REMARKS

• Annotated Marked-up Drawings

FIG. 2

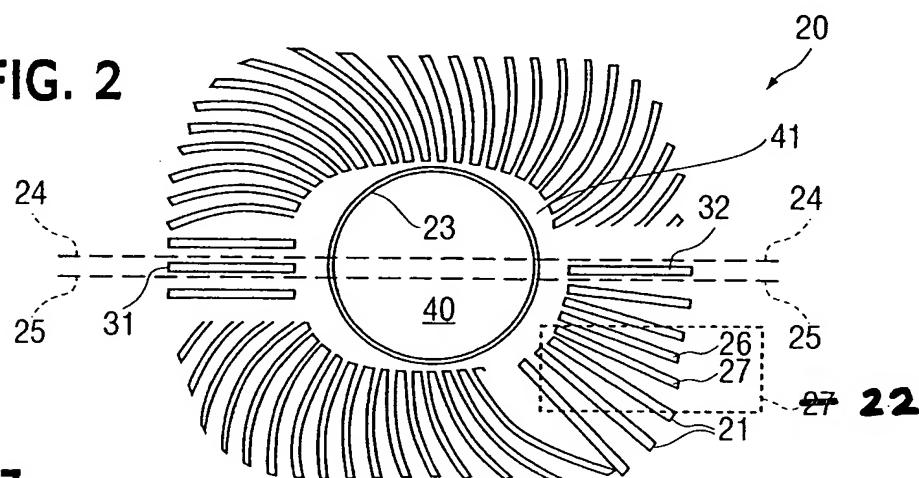
The drawings were objected to under 37 C.F.R. 1.84(p)(4) as designating two different elements in Fig. 2 as the reference "27." The drawings were further objected to under 37 C.F.R. 1.84(p)(5) as describing the reference "22" in the specification, but not showing it in the drawings. The drawings were also objected to under 37 C.F.R. 1.83(a) as not showing "the fan" of claim 1 in the drawings.

Attached are a replacement sheet and an annotated sheet showing changes to Fig. 2. The change corrects a typographical error, replacing one reference "27" with "22." Claim 1 has been amended to cancel the objected to language. Accordingly, the drawing objections are overcome.
